Muncy Valley Hospital

RE: License No. 37-18239-01
Docket No. 030-14714
Control No. 106732

Referencing the above, we will attempt to address your concerns as they appear in your letter dated March 16, 1987:

Long term decay
storage area.

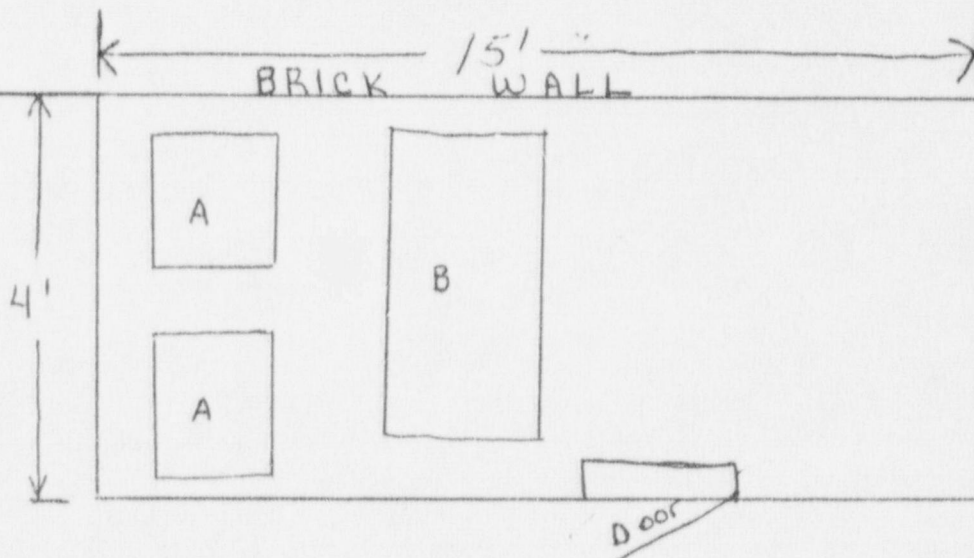
4. Our Nuclear Medicine Department design is as enclosed. The only change we will be making is with our long term decay storage area. This area will be moved from its existing location in the elevator mechanical room to an area to the rear of the Hospital. This area has limited access to personnel of the Nuclear Medicine Department and the Director of Maintenance. Within this area, we will have a 3/4 inch plywood box with a padlock which will only be accessible to Nuclear Medicine personnel. The previous storage area will be surveyed by our consultant Physicist prior to its release for unrestricted use.
